## MCDOWELL MOUNTAIN MANOR

Jesus Murillo  
City of Scottsdale-Senior Planner  
7447 East Indian School Road  
Scottsdale, AZ 85251

**General Plan, Zoning Ordinance, and Scottsdale Revise Code Significant Issues**

**THE FOLLOWING GENERAL PLAN COMMENTS 1-6 ARE WORD FOR WORD THE SAME AS THE COMMENTS WE RECEIVED IN THE 1<sup>ST</sup> REVIEW COMMENTS. WE ADDRESSED THESE ISSUES IN OUR SECOND REVIEW. THERE IS NO INDICATION OF A REVIEW OF OUR RESPONSES AND CORRECTIONS AND IF STAFF IS IN AGREEMENT OR IF THERE ARE STILL ISSUES TO DISCUSS. A COPY OF OUR LETTER WITH THE RESPONSES TO THE FIRST REVIEW COMMENTS IS ATTACHED.**

CONCEPTUAL LANDSCAPE PLAN  
MCDOWELL MOUNTAIN MANOR

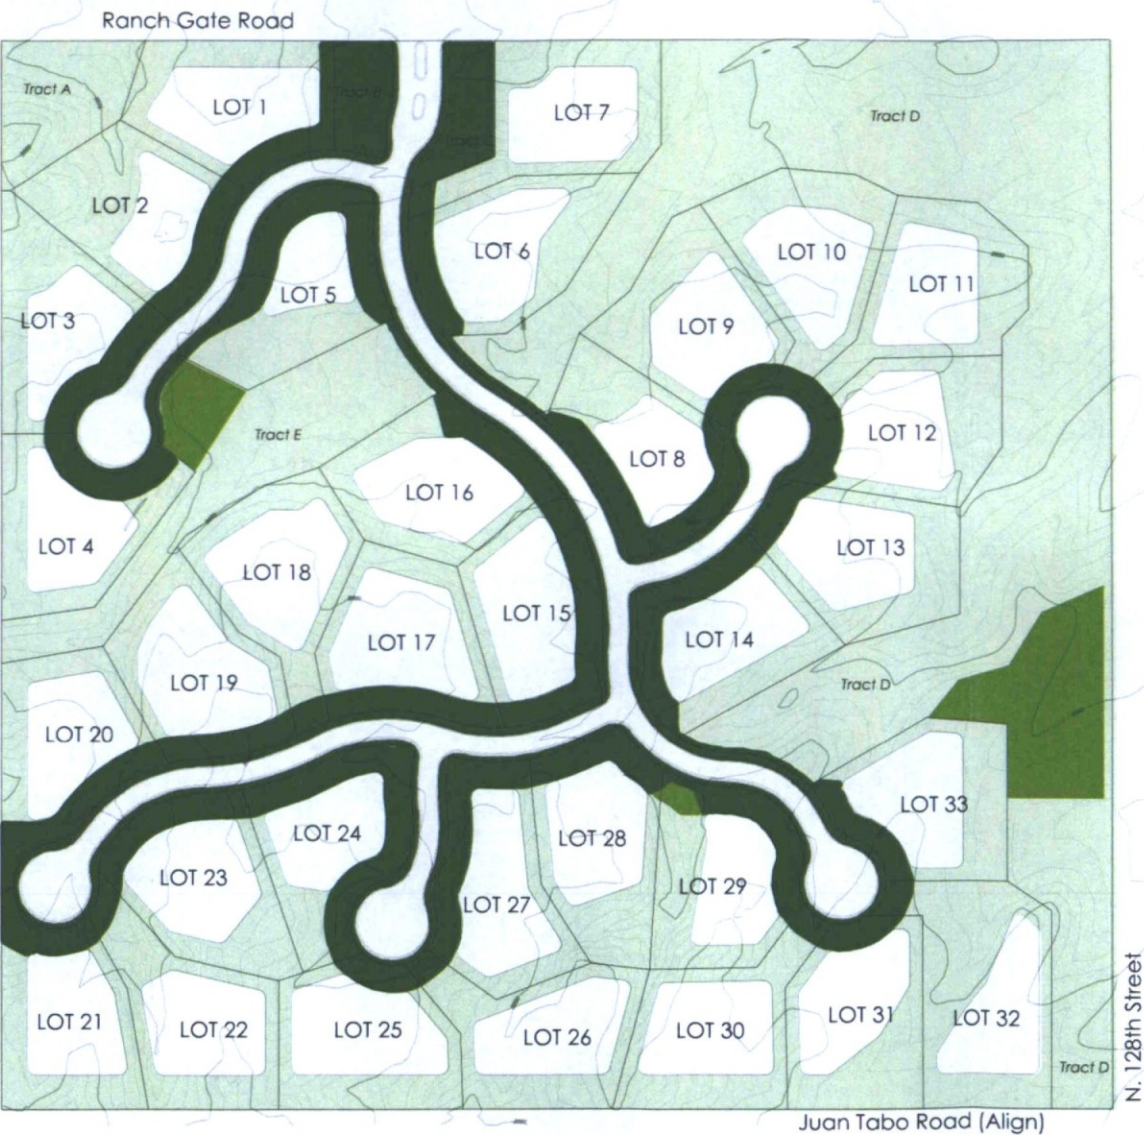
10. The ESL ordinance limits the maximum revegetated NAOS area to thirty (30%) percent of the required NAOS area (Ordinance Sec. 1060.D.2). Please update the Conceptual Landscape Plan, and NAOS Plan, to provide the approximate square-footage and percentage of disturbed and revegetated NAOS. Please include the area within the building envelope that will have walls adjacent to NAOS (5-foot Reveg Area).

**THE CONCEPTUAL LANDSCAPE PLAN HAS BEEN UPDATED**

# NATURAL AREA OPEN SPACE PLAN MCDOWELL MOUNTAIN MANOR

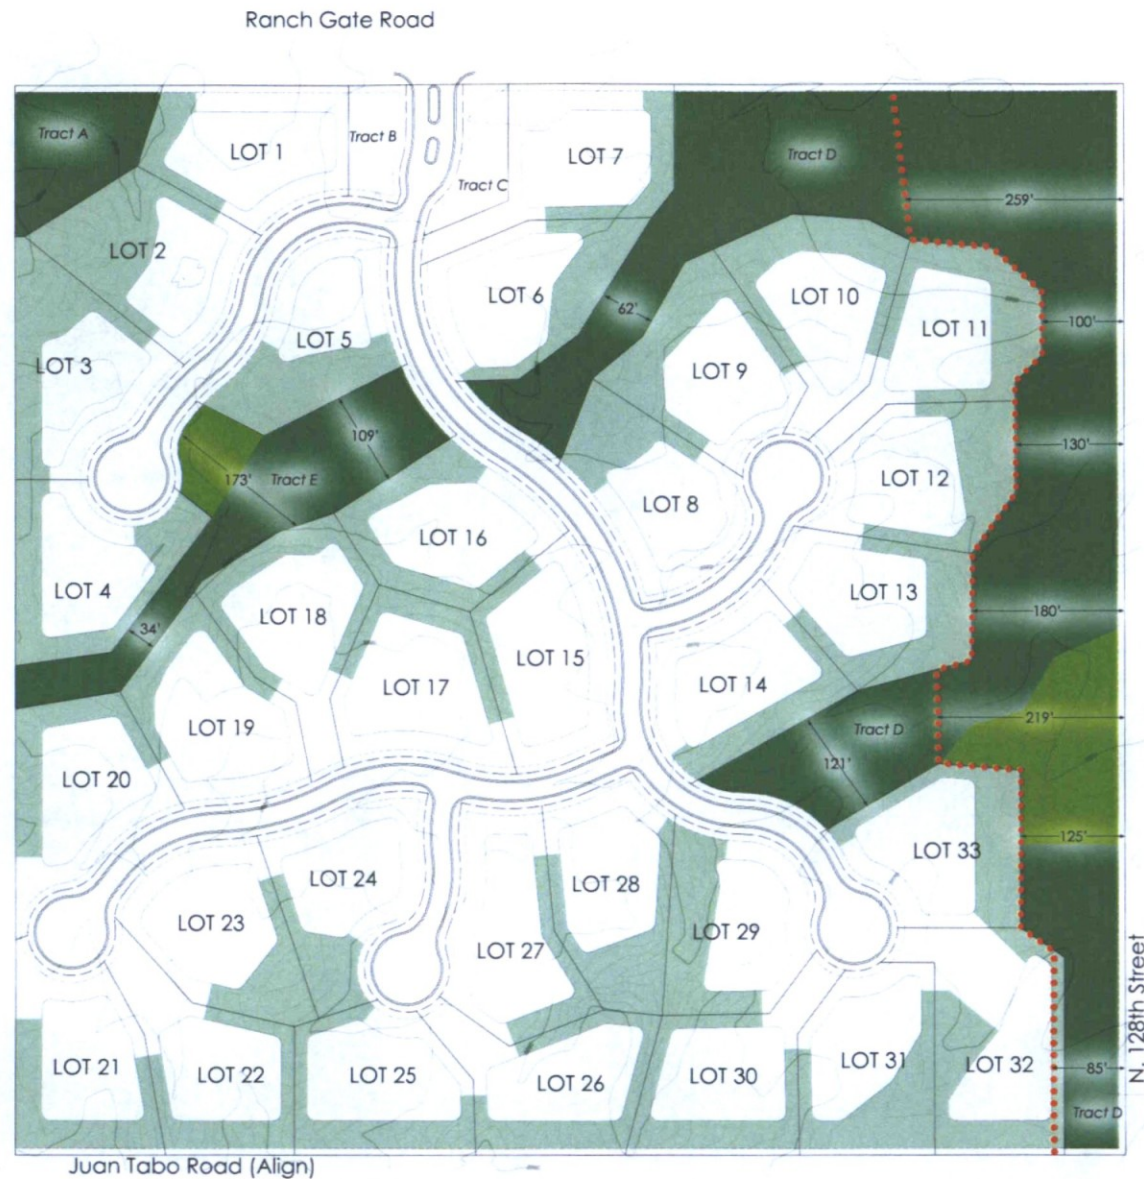
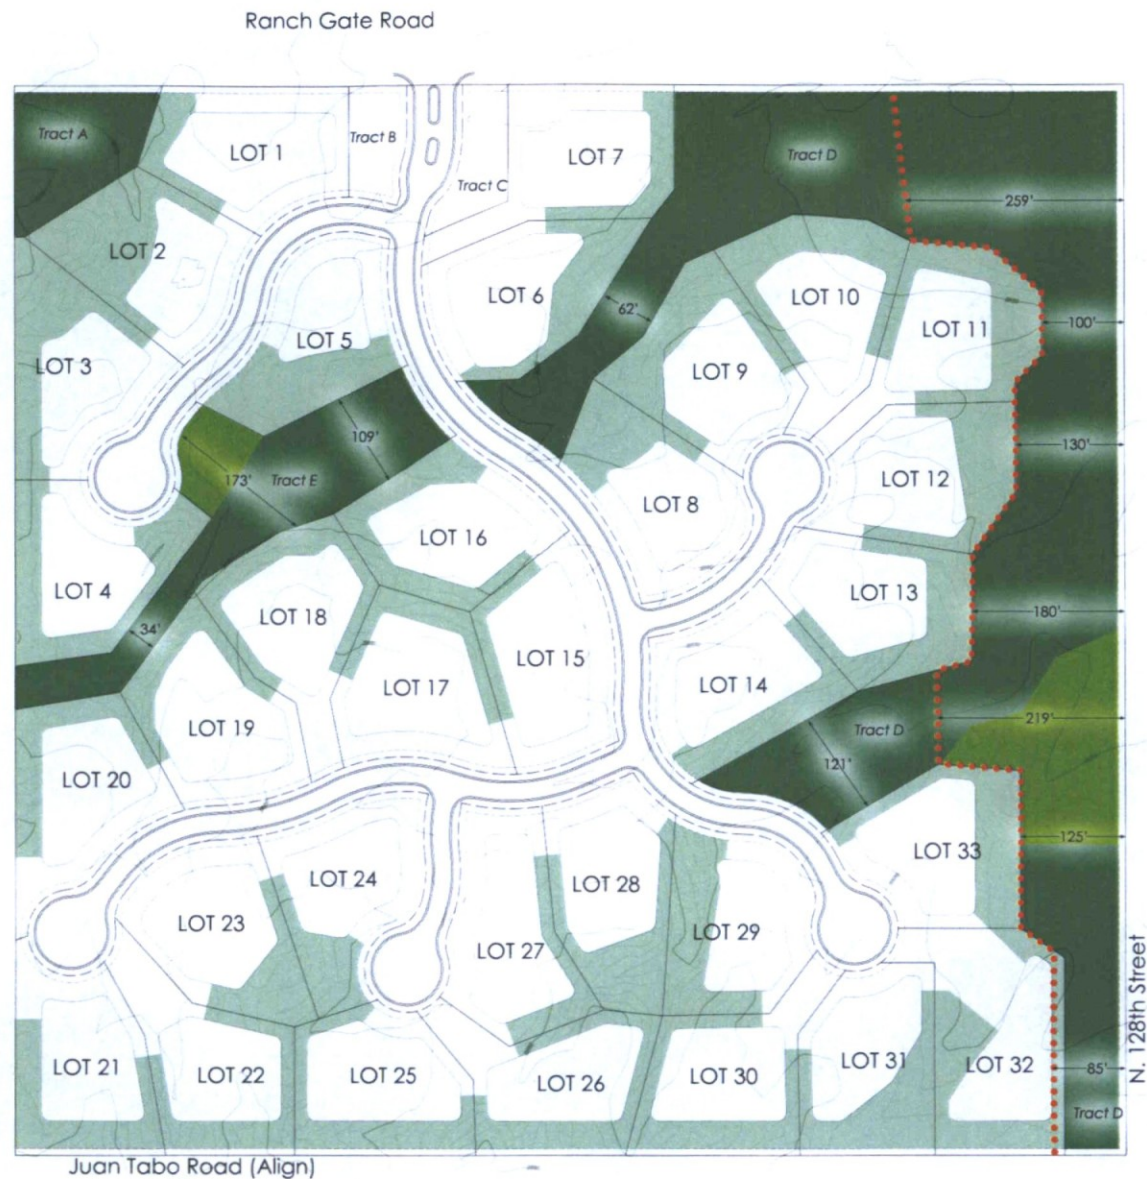
9. Please provide NAOS data table (Ordinance Section 6.1060.A). NAOS data table must include required NAOS, provided NAOS, undisturbed NAOS square-footage and percentage, and undisturbed NAOS square footage and percentage.

**THIS COMMENT IS IDENTICAL TO ITEM 10 OF THE FIRST REVIEW LETTER. AS A RESULT OF THAT FIRST REVIEW COMMENT, THIS DATA WAS PLACED ON THE NAOS EXHIBIT AND INCLUDED WITH THE SECOND SUBMITTAL. PLEASE ADVISE IF THERE ARE FURTHER CORRECTIONS REQUESTED.**

## SITE PLAN

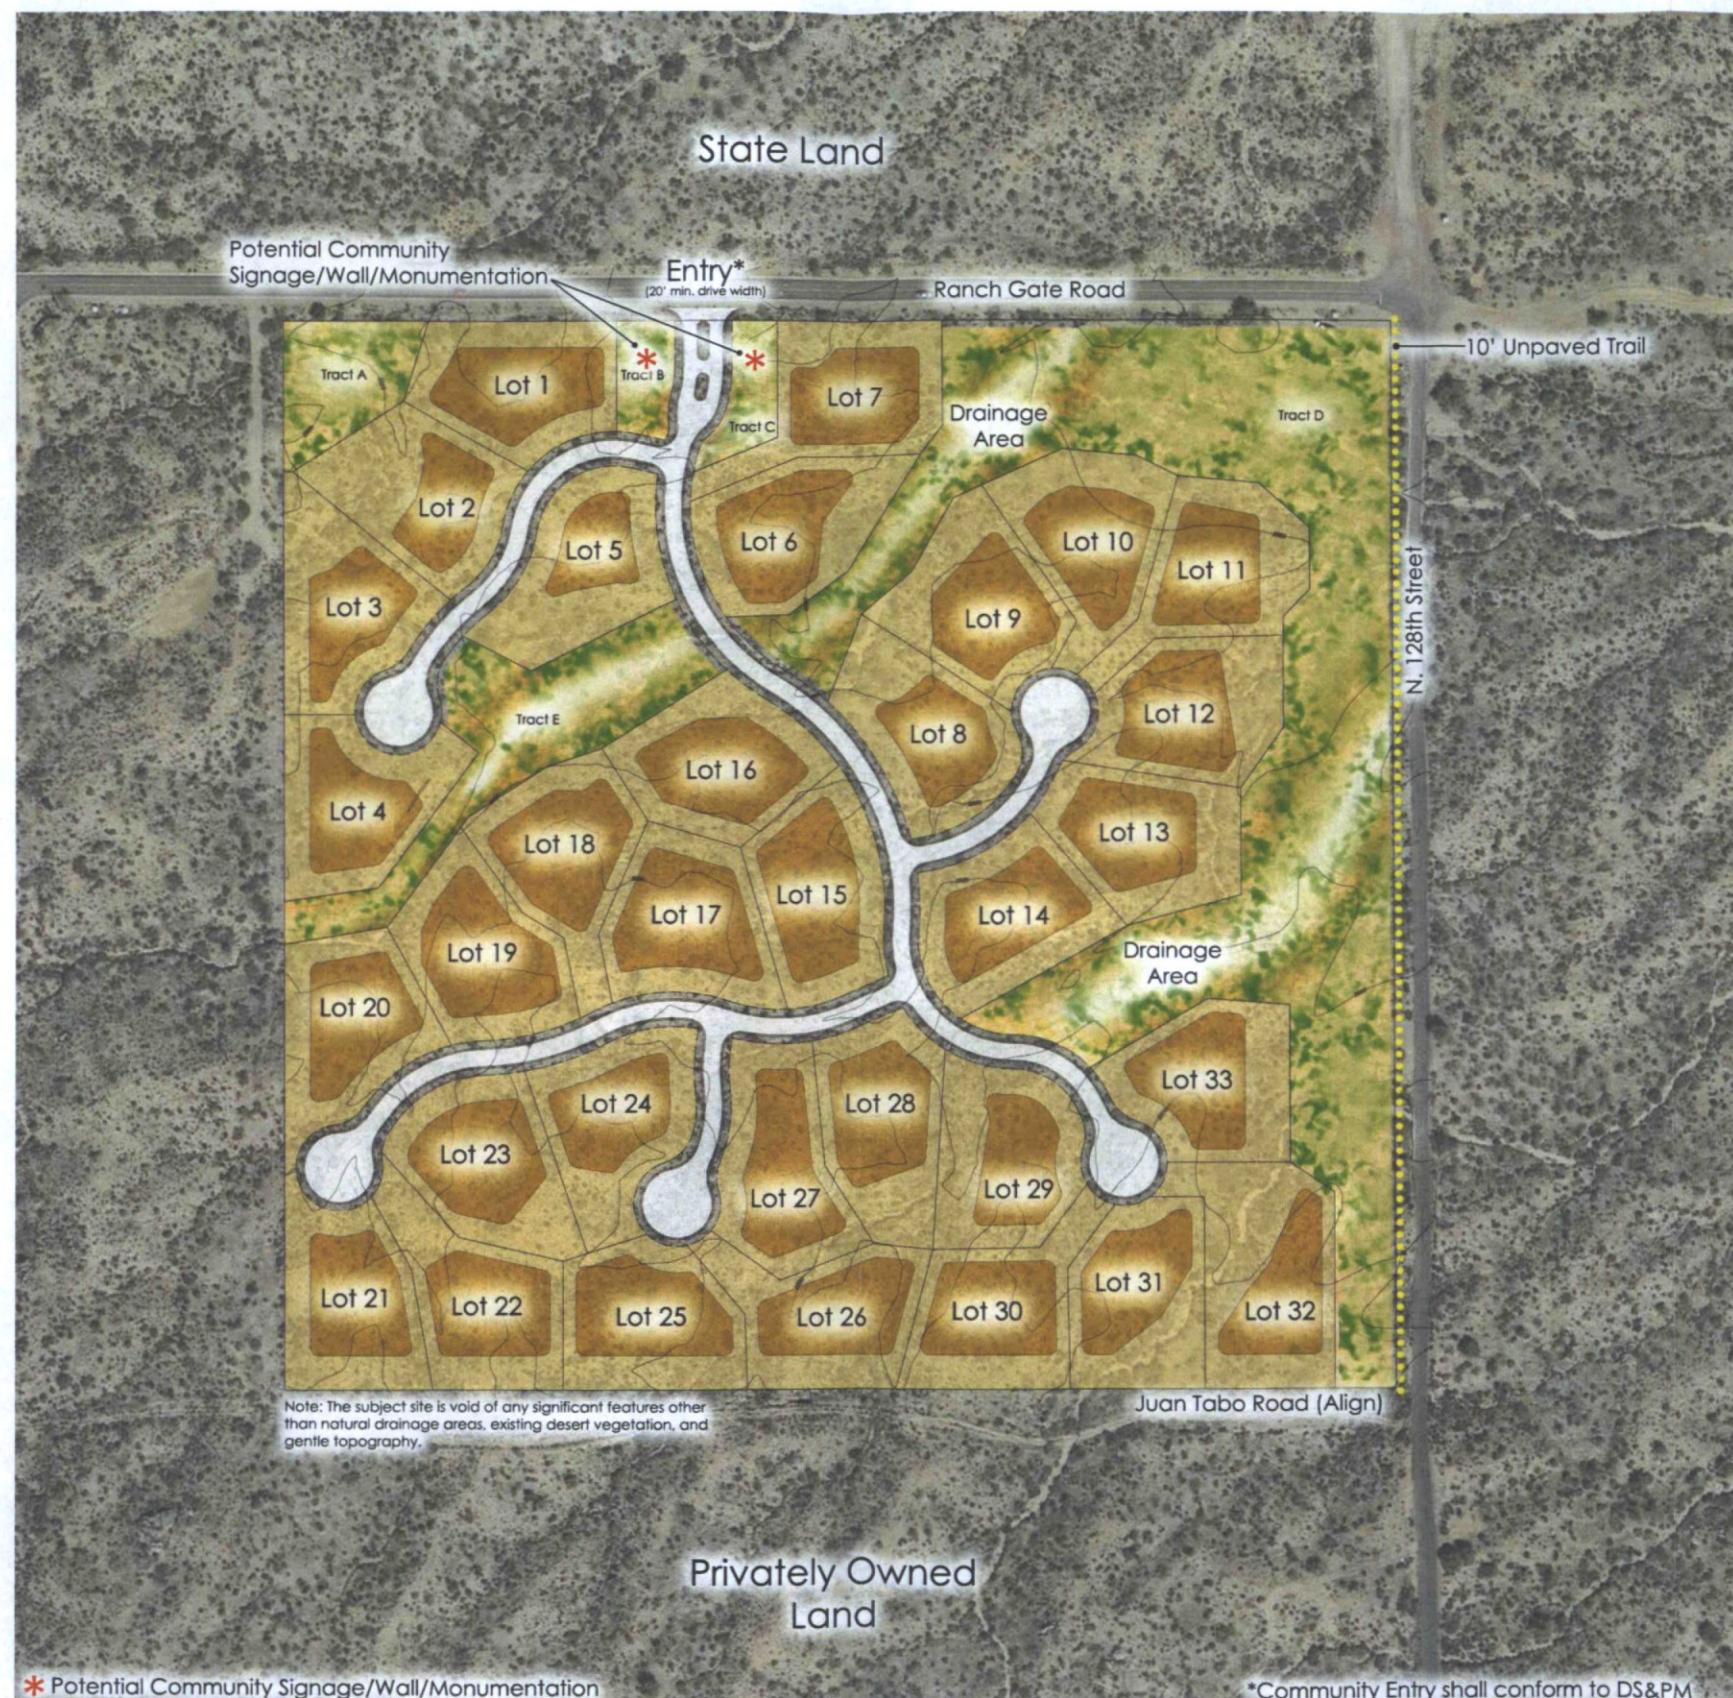
17. Please provide a proposed wall location exhibit with the resubmittal. Please update the project site plan to identify the location of all site walls on the site plan (DSPM Section 2-2.405).

20. Please consider eliminating lot "32" and incorporating the wash, located between lot "32" and the proposed cul-de-sac providing access to this lot, into the proposed tract "D." The drainage plan identifies 173 cfs running through this wash.

**WALL LOCATIONS HAVE BEEN INCLUDED ON THE SITE PLAN EXHIBIT**

**THIS DRIVEWAY CROSSING IS NOT PROHIBITED BY CODE. THIS ISSUE CAN BE LOOKED INTO IN GREATER DETAIL IN THE PRELIMINARY PLAT APPLICATION AND ADJUSTED IF NECESSARY, AT THAT POINT.**
